# **DOWNTOWN BRAMPTON FLOOD PROTECTION**

*Addendum to the Environmental Study Report*

Downtown Brampton Flood Protection Addendum to Environmental Study Report  
 City of Brampton and Toronto and Region Conservation Authority

Figure 1 CN Crossing Alternative Approved in ESR

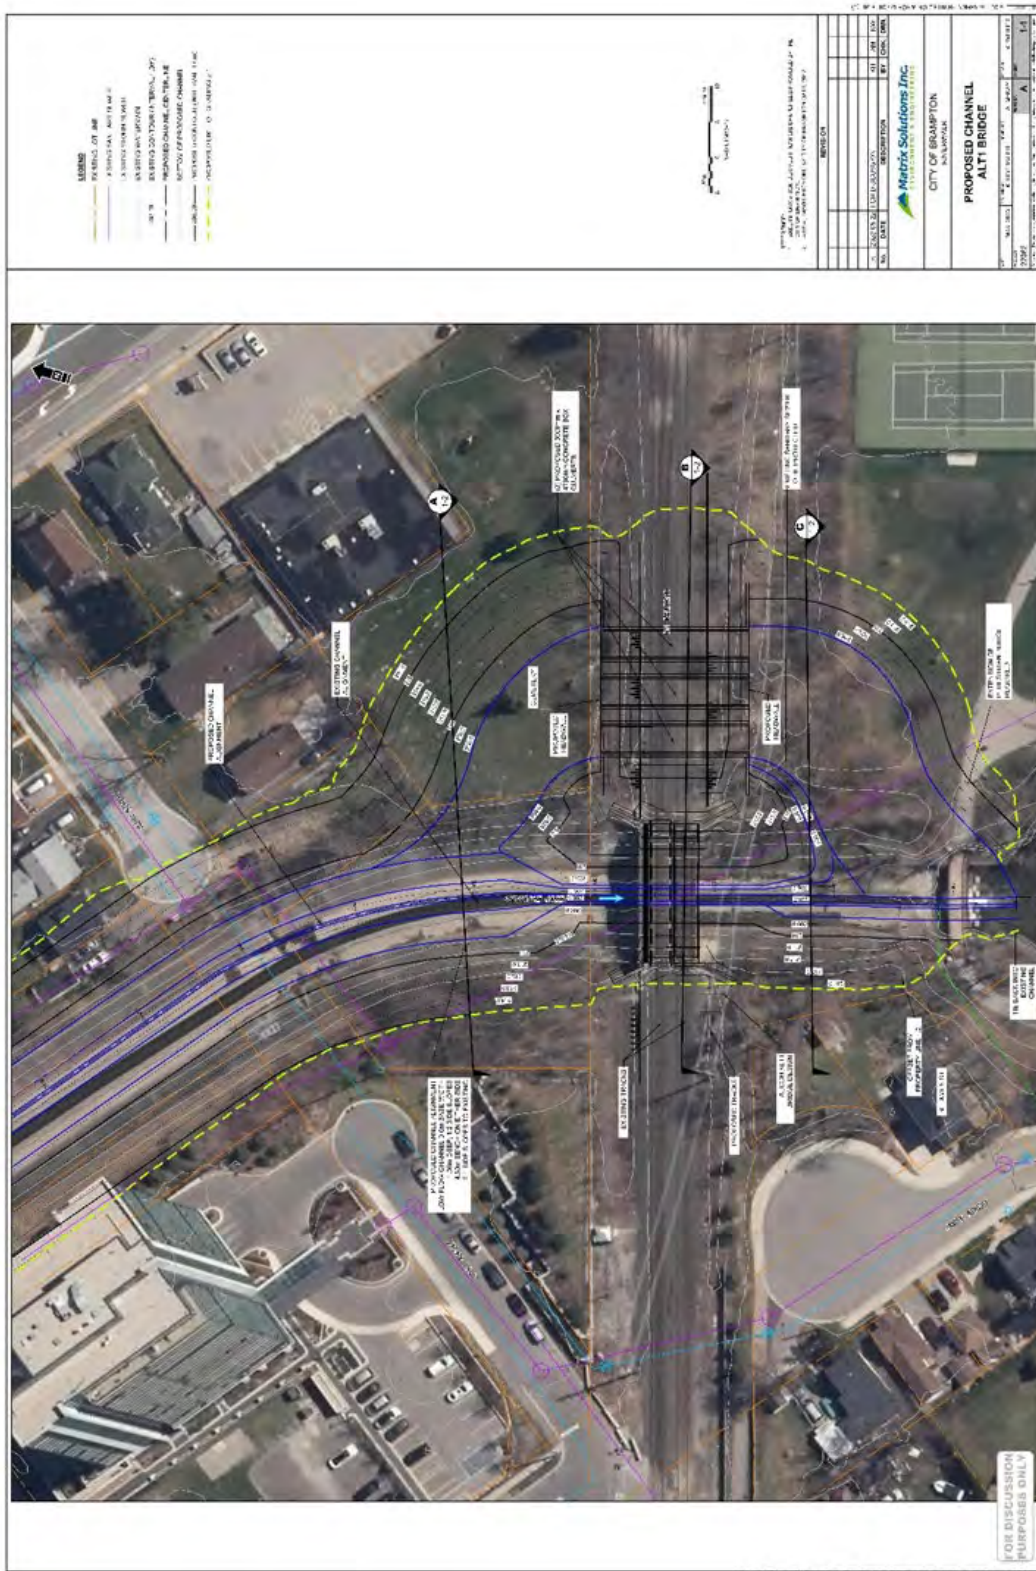
The EA identified the CN rail crossing as a significant constraint for the project and proposed a solution for providing additional conveyance needed for passing the Regulatory storm via the installation of three culverts located to the east of the existing crossing (see Figure 1). However, this alternative resulted in significant impacts on the St Mary's Heritage Cemetery likely resulting in the relocation of graves. The question of how to provide for the flood conveyance at the CN crossing was to be further investigated during detailed design.

Alternative 3 was chosen as the new preferred alternative to provide flood conveyance for Etobicoke Creek at the CN crossing. This alternative includes 3 box culverts on the west side of Etobicoke Creek. The proposed grading limit was kept at a 2:1 side slope but could be potentially steepened with structural engineering solutions to lessen impacts to the John Street and James Street cul-de-sacs. The slope stability assessment is being undertaken as part of detailed design. This alternative avoids impact to the cemetery however it will impact the house and property at 30 James Street and the cul-de-sacs. While both the cemetery and the house at 30 James Street have heritage value, the relocation of the cemetery has more
